AGENDA FOR THE CANTERBURY BANKSTOWN LOCAL PLANNING PANEL MEETING

ITEM 1	DA-1133/2020 - 409 Burwood Road, BELMORE
	Alterations to existing commercial building and additions to the rear including residential apartments and at grade parking, for one commercial tenancy at Ground Level and 11 residential apartments over four storeys.
FILE	DA-1133/2020 – Bunmarra/Roselands
ZONING	B2 Local Centre
DATE OF LODGEMENT	8 December 2020 (Amended Plans received on 16 August 2021).
APPLICANT	Toto Mesiti
OWNERS	Toto Mesiti
ESTIMATED VALUE	\$3,154,000
AUTHOR	Planning

DA-1133/2020 ASSESSMENT REPORT

[14] & [15] Setbacks

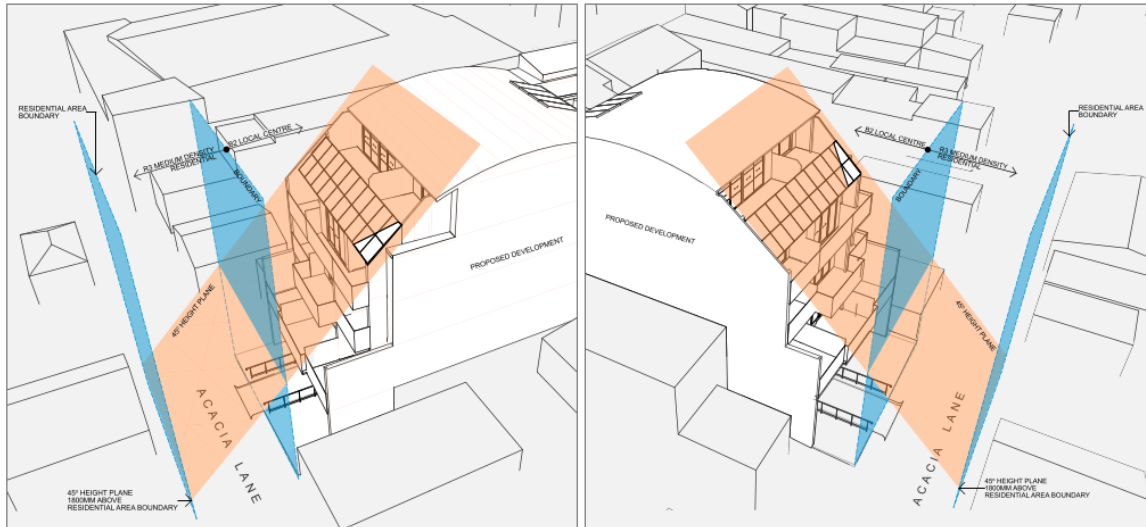
Part D1.3.4 Setbacks refers to the building height plane and the controls state the following:

On boundary with residential zone – rear setback

- C7 Establish a 45° height plane projected at 6 m from the residential zone boundary.
- C8 Provide minimum 6m setback to the residential zone boundary.
- C9 A two-storey limit on the boundary with residential zone applies.
- C10 A setback to a rear lane is not required.

The proposed development seeks an encroachment within the 45 degree height plane and a two-storey limit on the boundary with residential zone.

The applicant has provided a height plane blanket demonstrating the areas of encroachment within the 45degree which occurs to a small portion on level 4 in the north-eastern corner of the site.

- The encroachment occurs to a small portion on level 4 (5th storey).
- The design achieves compliance with the building separation requirements specified within the ADG, including the additional setback requirements to the eastern boundary given the land to the east comprises a lower density residential zone (R3 Medium Density).
- Although the design incorporates more than 2 storeys on the residential boundary (along the rear boundary), the building is contained within the building height plane and as stated above is compliant with the ADG separation requirements
- In light of the above, the proposed variation to the rear height plane is considered acceptable in this instance, if the application was to be supported
